RECORD PLANS	
CONTRACTOR:	RENAUD BROTHERS, INC. – VERNON, VT
RESIDENT ENGINEER:	DARYL BASSETT
CONSTRUCTION BEGAN:	DECEMBER 13, 2010
CONSTRUCTION COMPLETE:	JUNE 5, 2013
RECORD PLANS BY:	DARYL BASSETT, NICK GARBACIK & P. BANNERMAN

STATE OF VERMONT
AGENCY OF TRANSPORTATION

PROPOSED IMPROVEMENT
BRIDGE PROJECT
TOWN OF HARTFORD (WILDER)
COUNTY OF WINDSOR

ROUTE NO : TH 29, CLASS 3 (LOCAL) BRIDGE NO : 38

LAYOUT SHEET

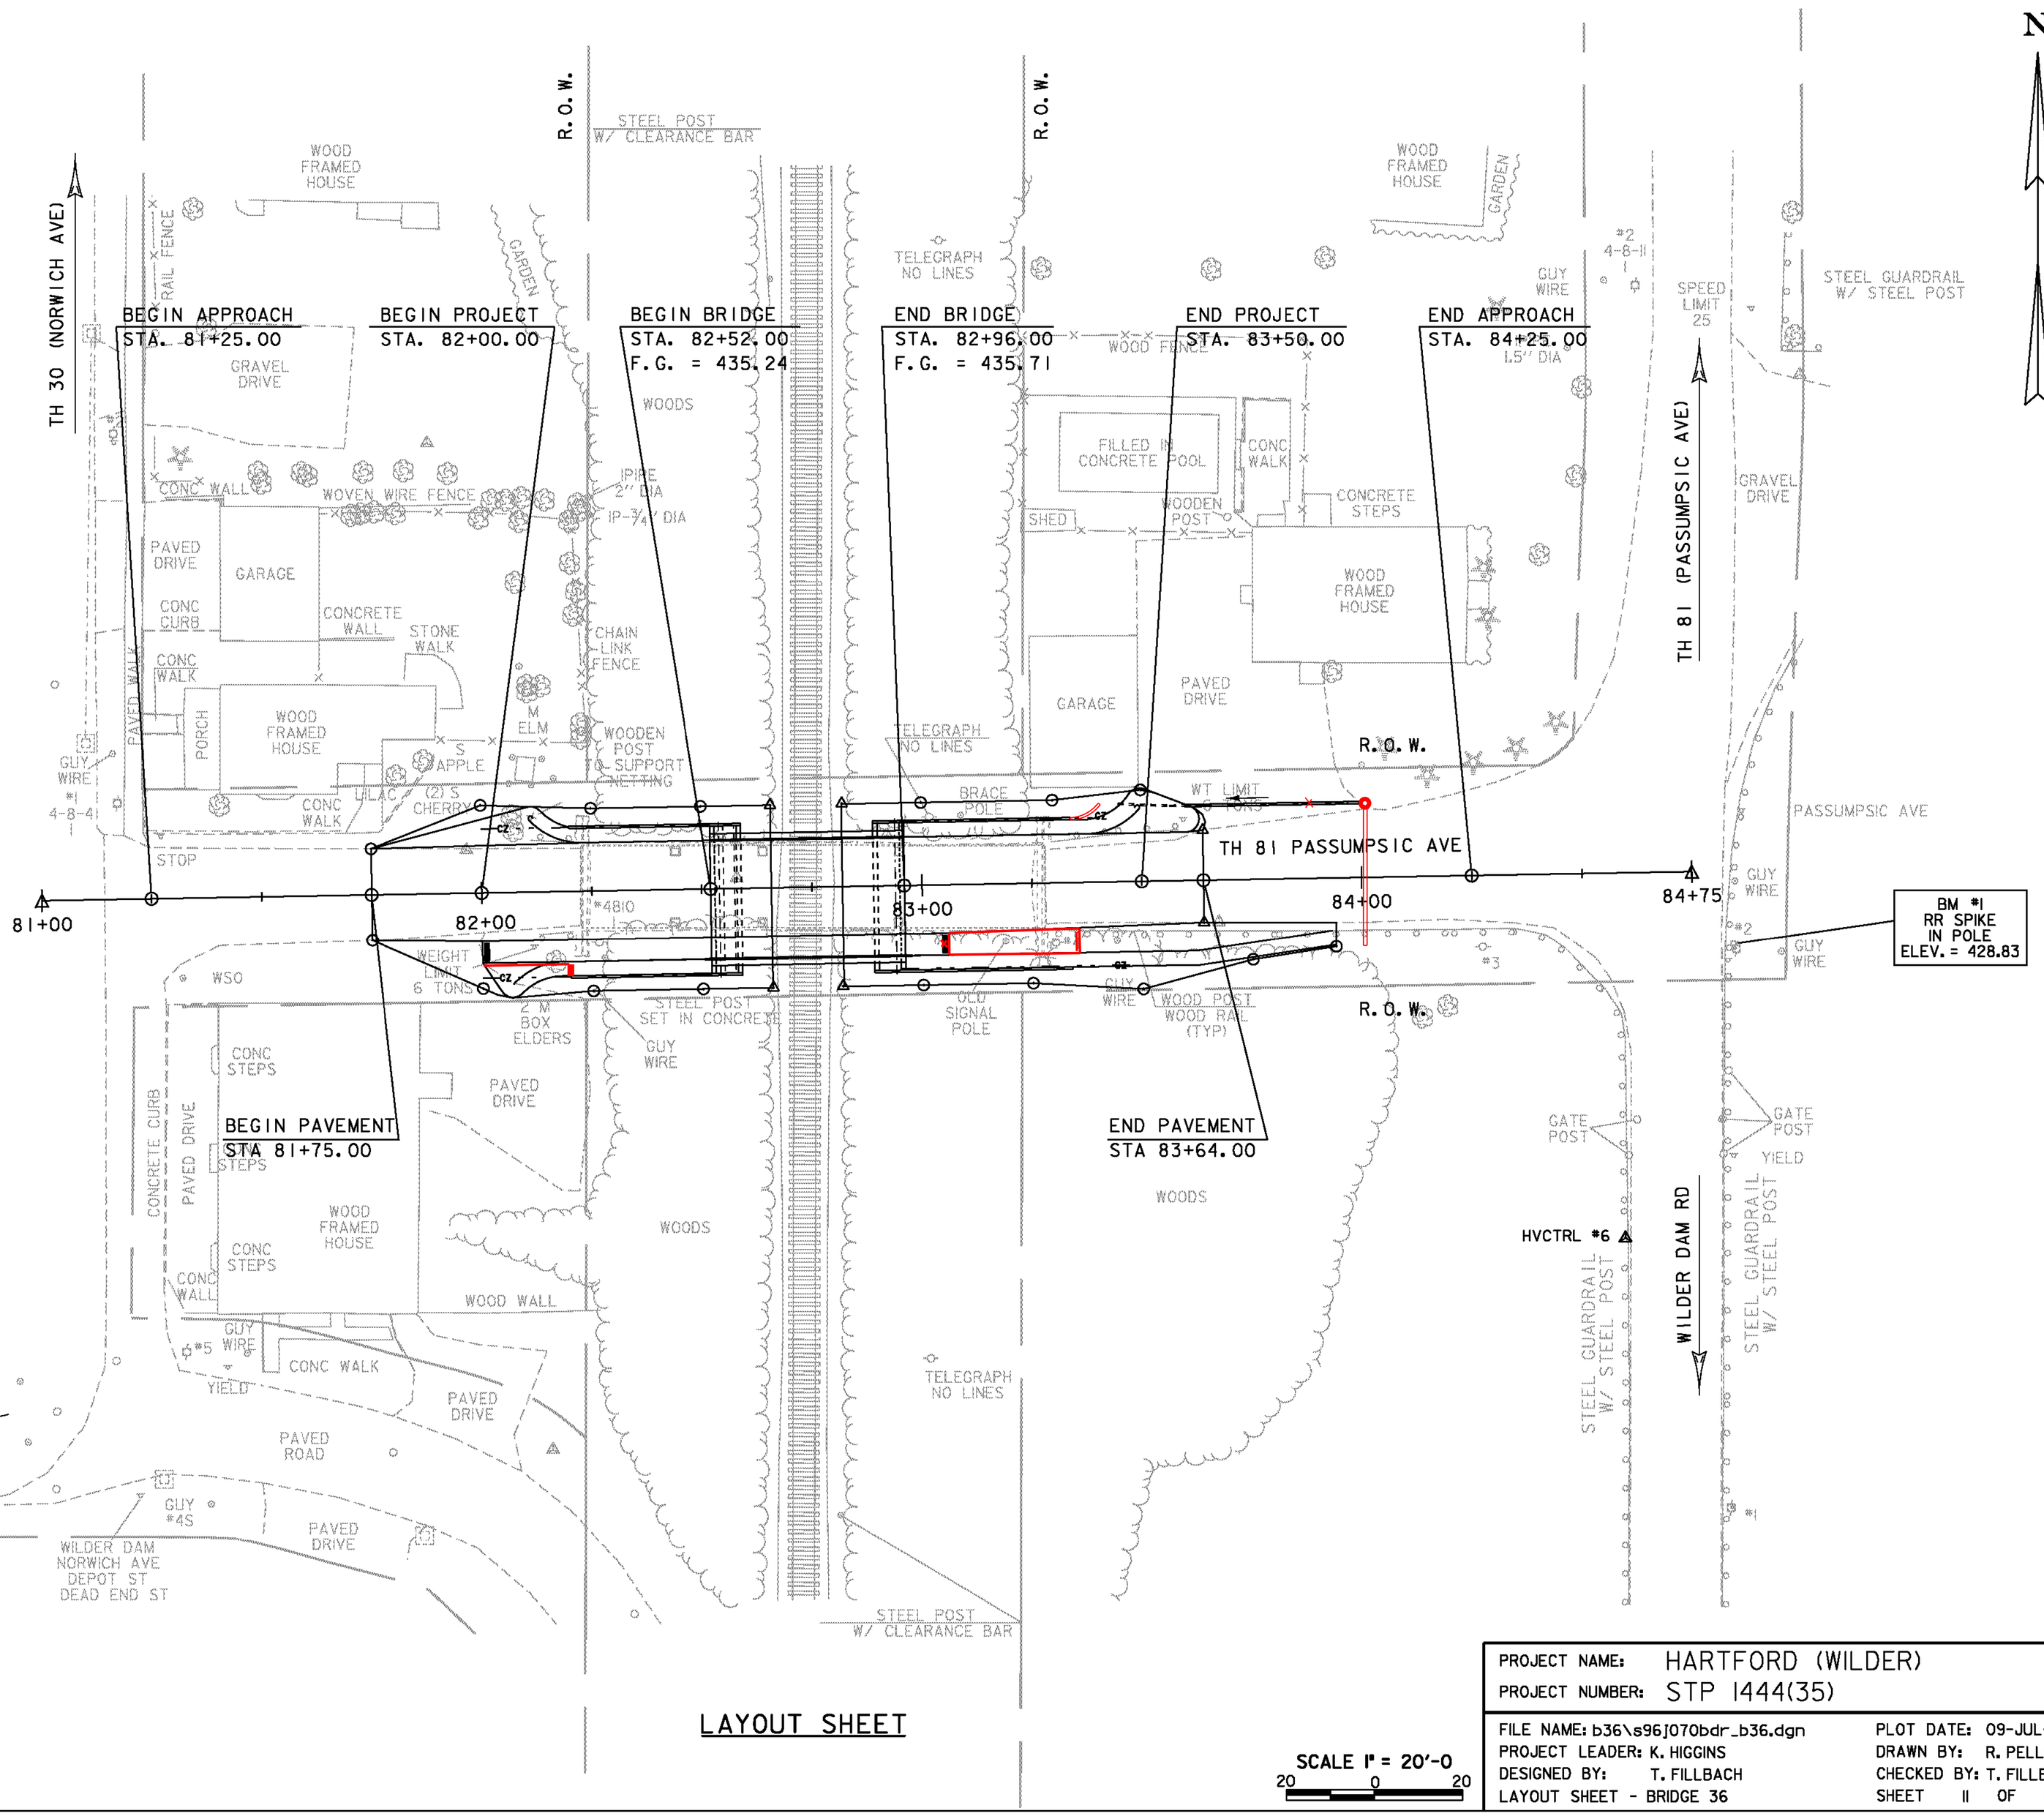
~~REMOVE AND RESET GUARDRAIL~~
~~STA 83+80 - 84+00 RT~~

~~SPECIAL PROVISION (TRENCH DRAIN)~~
~~STA 83+45.00 - 84+00.00 LT~~

DETECTABLE WARNING SURFACE
STA 82+01.50 RT
STA ~~83+04.80 RT~~
83+35 RT

TH 81 (PASSUMPSIC AVE) PROFILE

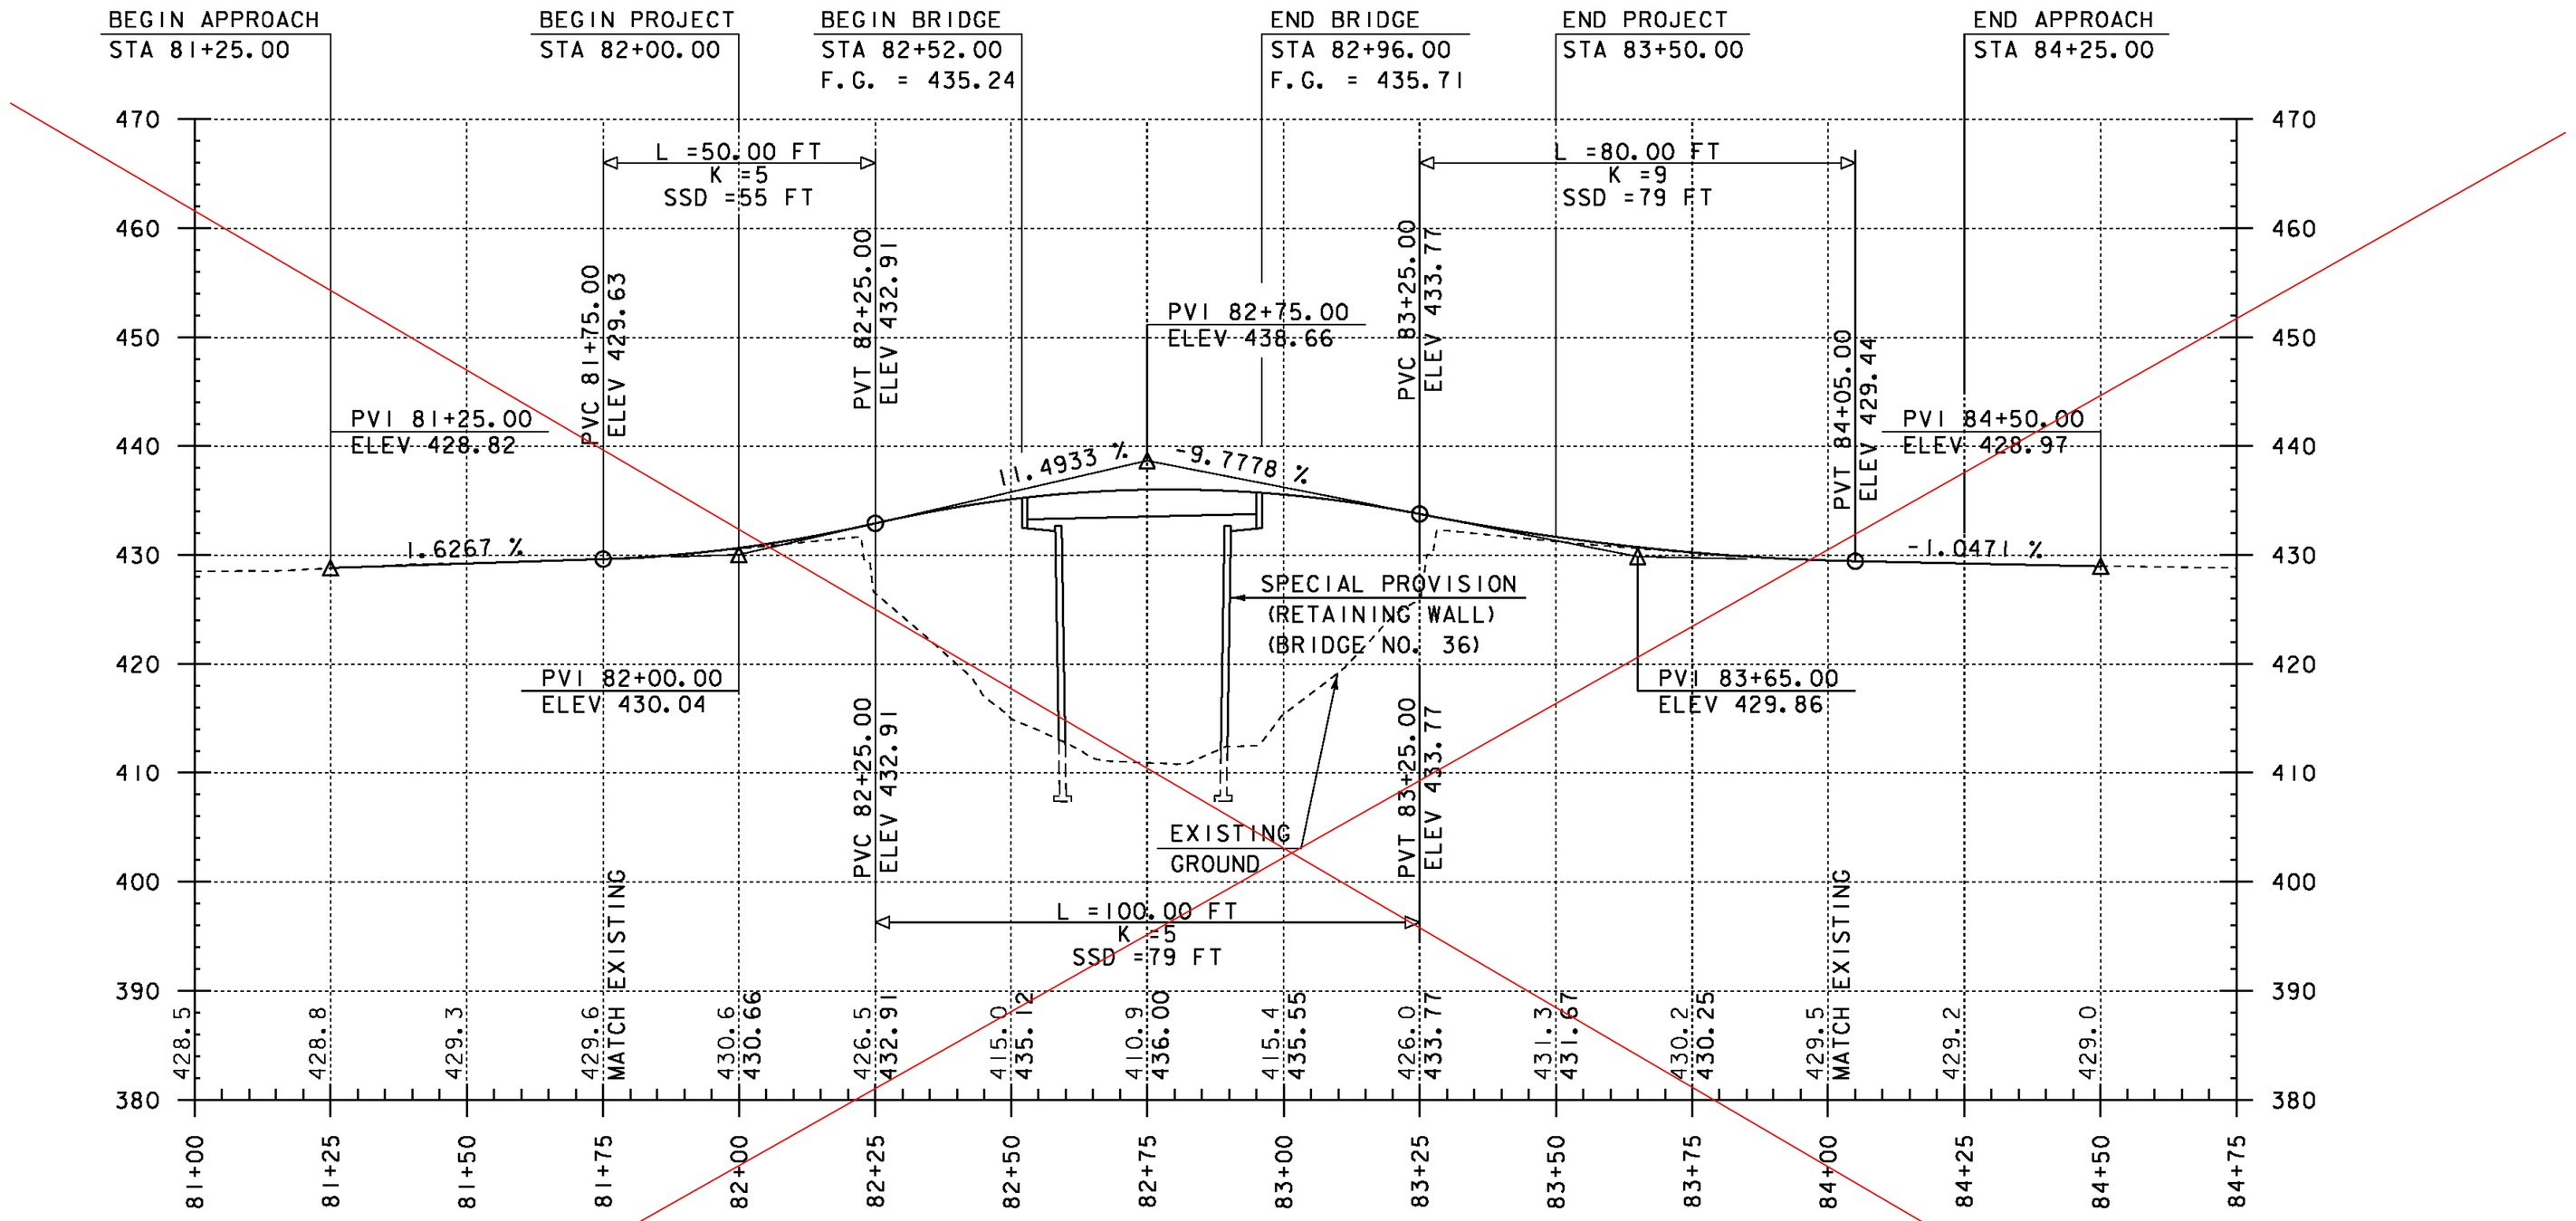
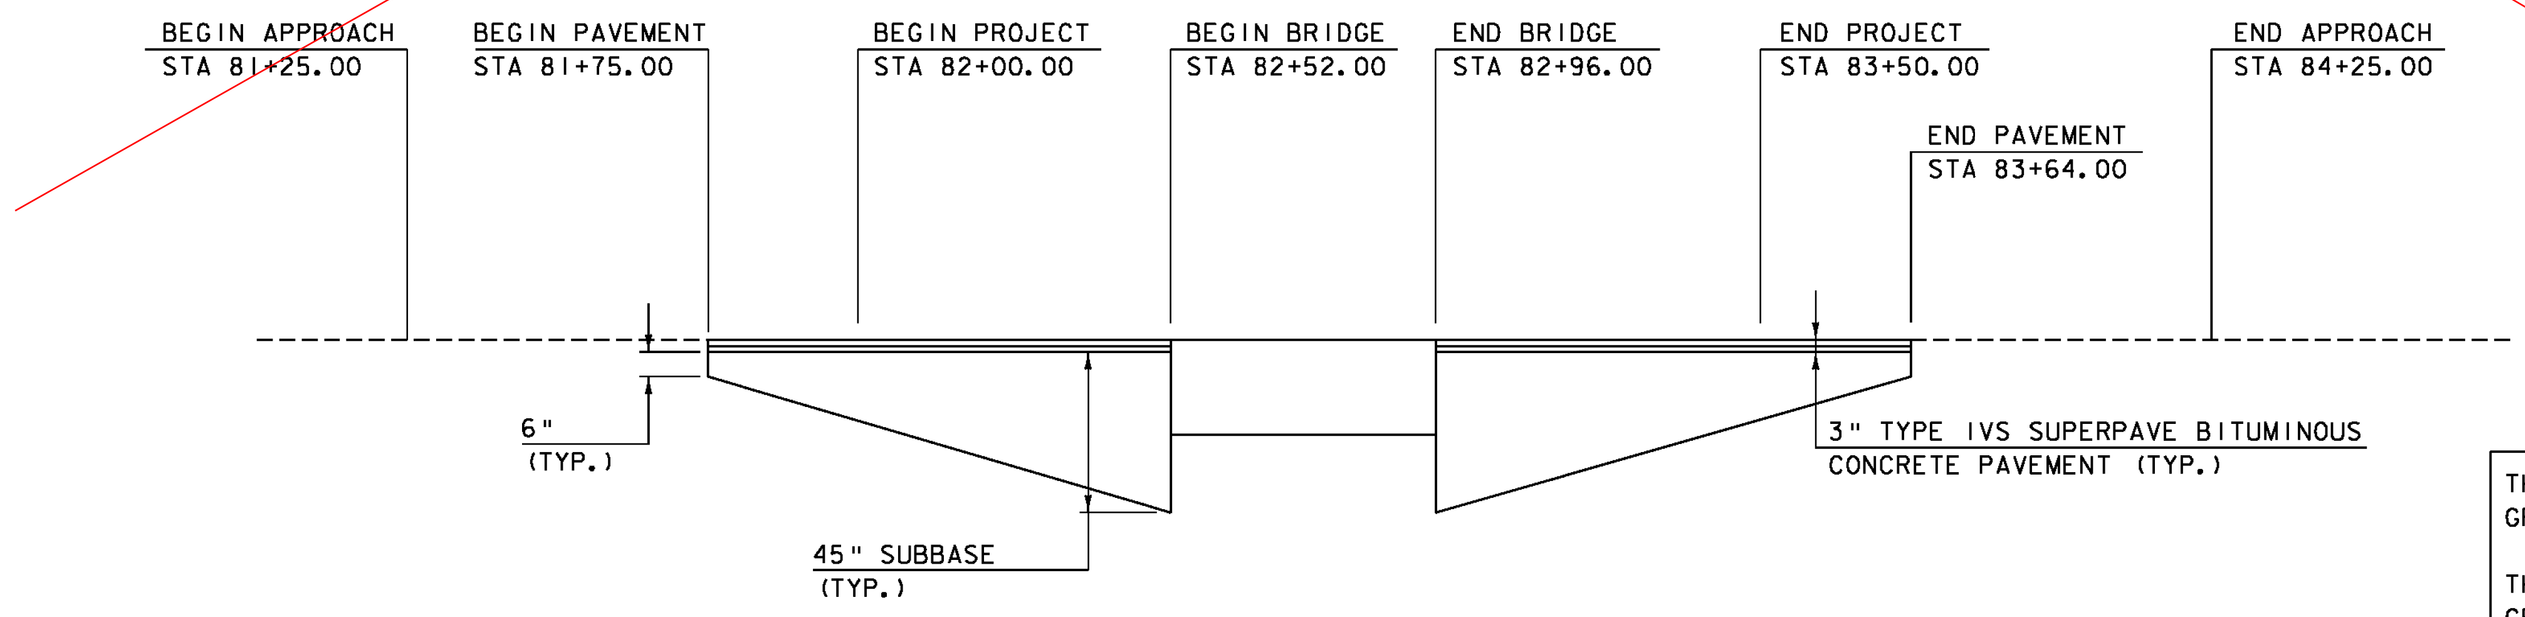
SEE REVISED PROFILE PASSUMPSIC AVE1
SHEET 2 OF 11 DATED 10/4/11

UTILITY LAYOUT SHEET

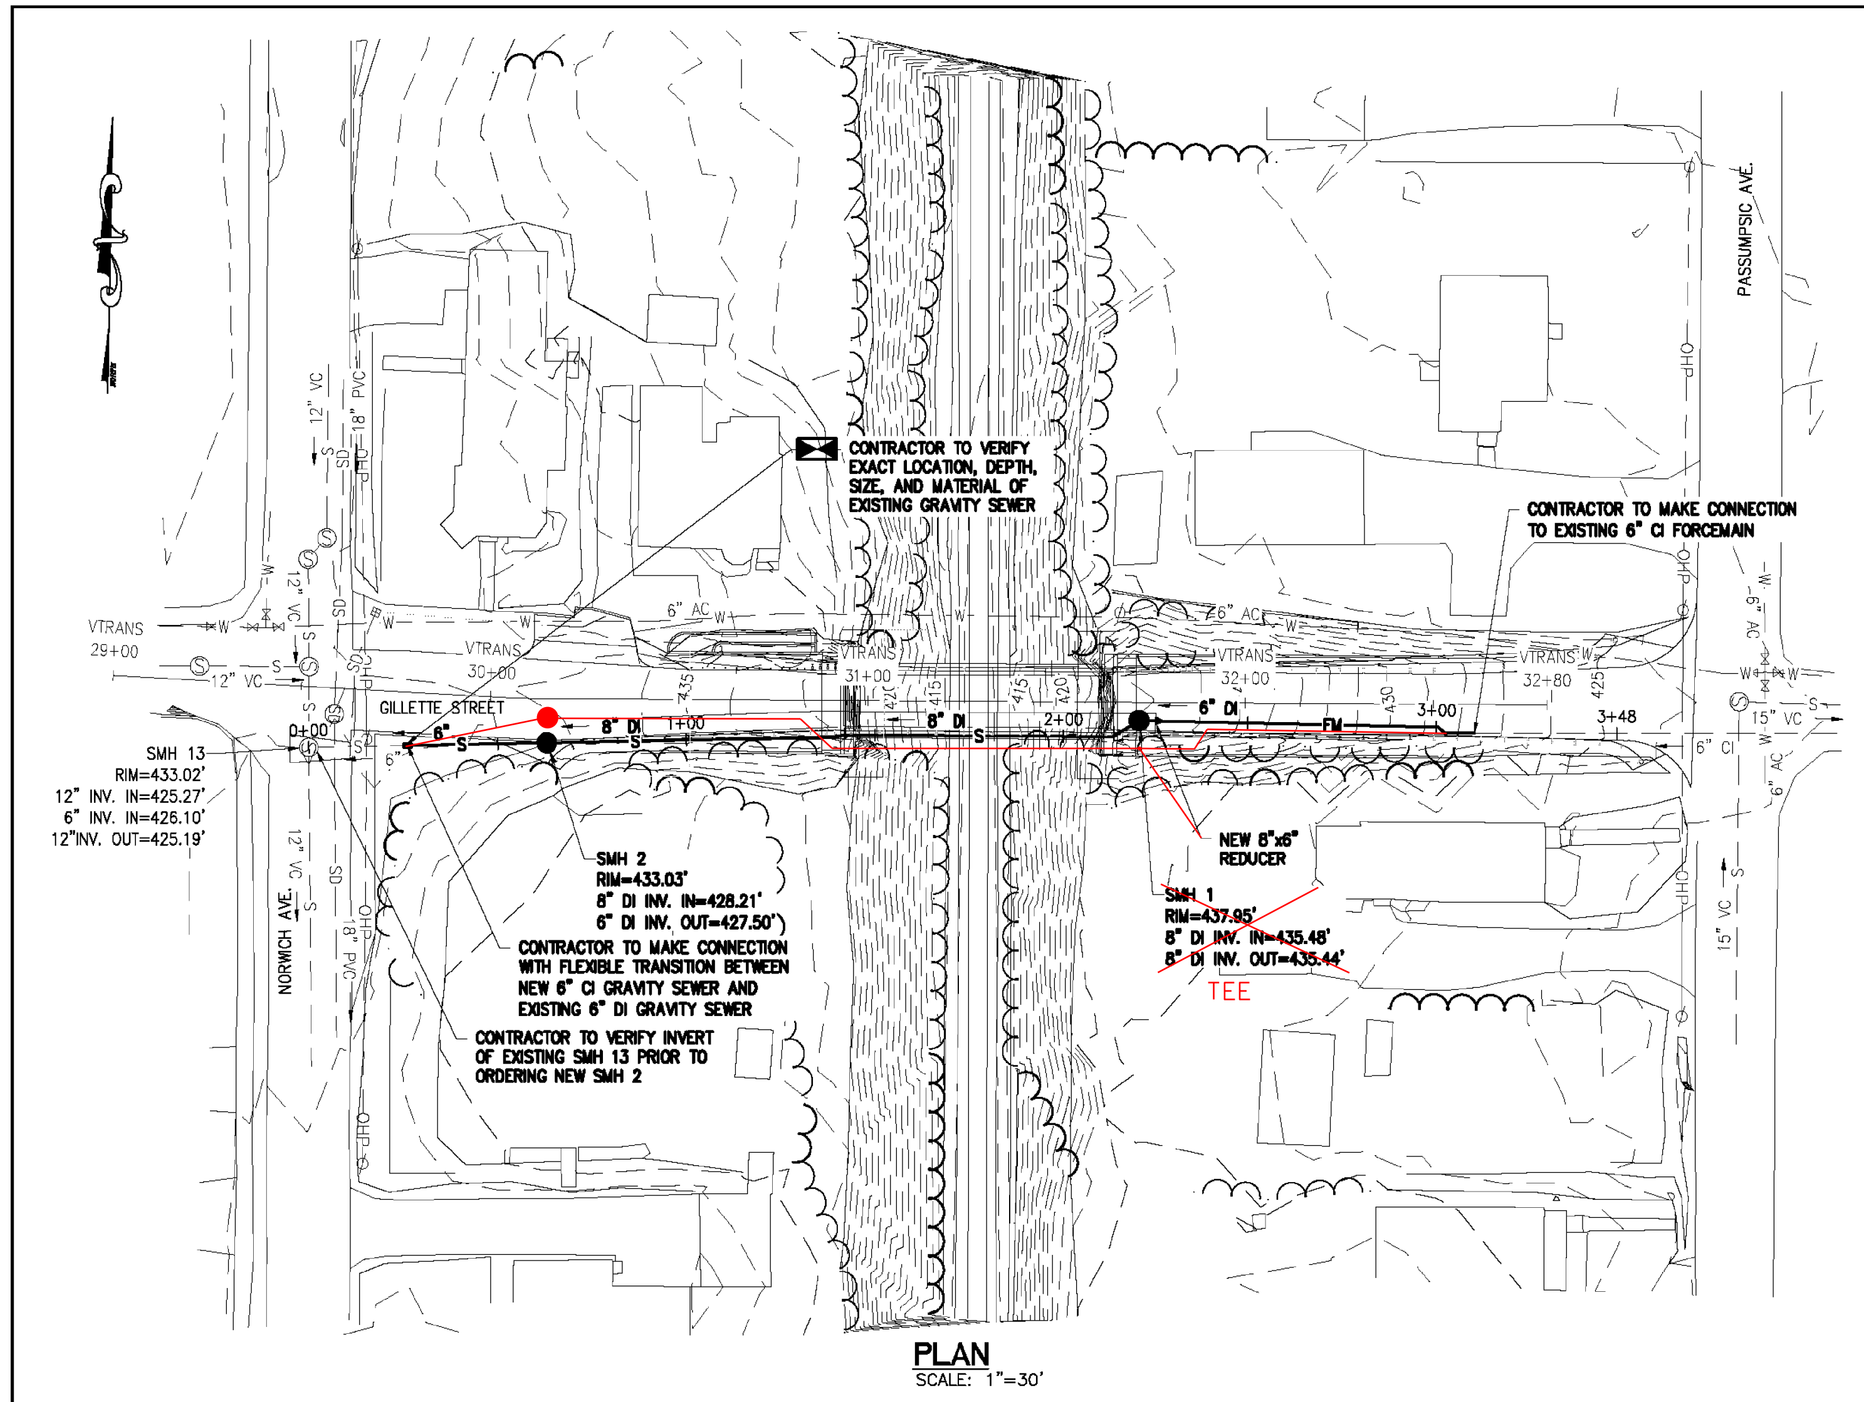
SPECIAL PROVISION (PRE-INSULATED DUCTILE IRON PIPE, CEMENT LINED) (SEWER) (8")
32.00
STA 30+~~16.50~~ - 30+41.50
STA 31+14.83 - 31+~~20.00~~
21.83

SPECIAL PROVISION (PRE-INSULATED DUCTILE IRON PIPE, CEMENT LINED) (SEWER) (6")
STA 31+~~20.00~~ - 31+~~45.00~~
21.83 50.00
